Access Compliance Report

Public Rights-of-Way

Intersection ID: 11783	Main Street: N_GRAHAM_ST	Cross Street: W_5TH_ST	Location: N
ADA ID: EACD401EA3B3	Ramp Type: BlendTrans1	Initial Pass/Fail: Pass	Overall Compliance: No
			Severity Score: 5

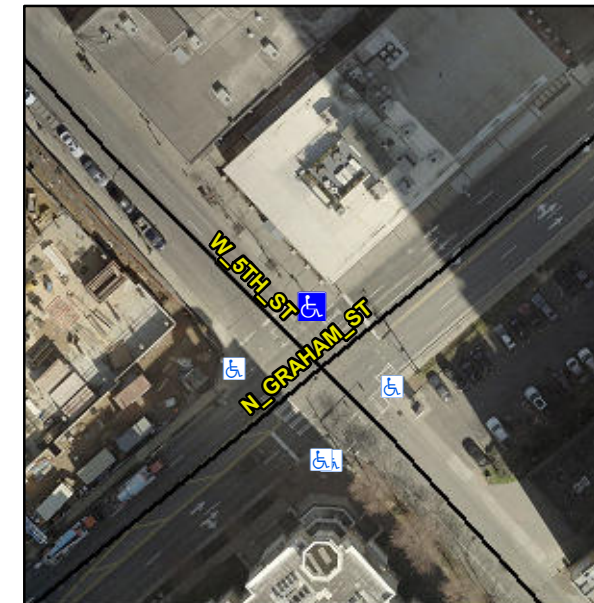
R304.5.3, Not Found, R305.2, R304.5.4

Compliance	Description	Data	Compliance	Description	Data
N/A	Ramp Length (in)	44.0	Yes	BlendTrans Slope (%)	0.4
Yes	Ramp Width (in)	50.0	Yes	BlendTrans XSlope (%)	0.5
N/A	Flare Type LT	Sloped	N/A	Flare Type RT	Sloped
Yes	Flare Slope LT (%)	5.4	Yes	Flare Slope RT (%)	2.1
N/A	Flare Traversable LT?	Yes	N/A	Flare Traversable RT?	Yes
Yes	Landing Length (in)	60.0	Yes	DWS Provided?	Yes
Yes	Landing Width (in)	50.0	Yes	DWS Contrast?	Yes
Yes	Landing Slope (%)	0.2	Yes	DWS Length (in)	24.0
No	Landing X Slope (%)	2.8	Yes	DWS Full Width?	Yes
N/A	Landing Curb? (Y/N)	No	No	DWS Offset (in)	8.0
N/A	Shared Landing?	No			
Yes	Gutter Ponding?	No	No	Gutter Slope (%)	6.2
Yes	Gutter Lip Ht (in)	0.0	Yes	Gutter X Slope (%)	1.4
N/A	Painted X Walk1?	Yes	N/A	Painted X Walk2?	Yes
	X Walk 1 Direction	To SW		X Walk 2 Direction	To SE
	X Walk 1 Width (in)	108.0		X Walk 2 Width (in)	110.0
	X Walk 1 Slope (%)	5.0		X Walk 2 Slope (%)	0.9
	X Walk 1 X Slope (%)	5.0		X Walk 2 X Slope (%)	5.2

Yes	Ramp inside XWalk1?	Yes	Yes	Ramp inside XWalk2?	Yes
	Road Slope (%)	1.1		Clear Space?	Yes
	Road X Slope (%)	6.6	No	Clear Space to XWalk (in)	45.0
Yes	Any Obstructions?	No	Yes	Storm Grate/Utility Hazard?	No
	Obstruction Type			Storm Grate/Utility Type	
		N/A			N/A
			Yes	Surface Condition? (G/P)	Good
			Yes	Curb Slope (%)	0.8

Remove & Replace Curb Ramp With Two New Directional Ramps or Equivalent. Restripe Crosswalk(s) To Provide Clear space. Remove & Replace Gutter.
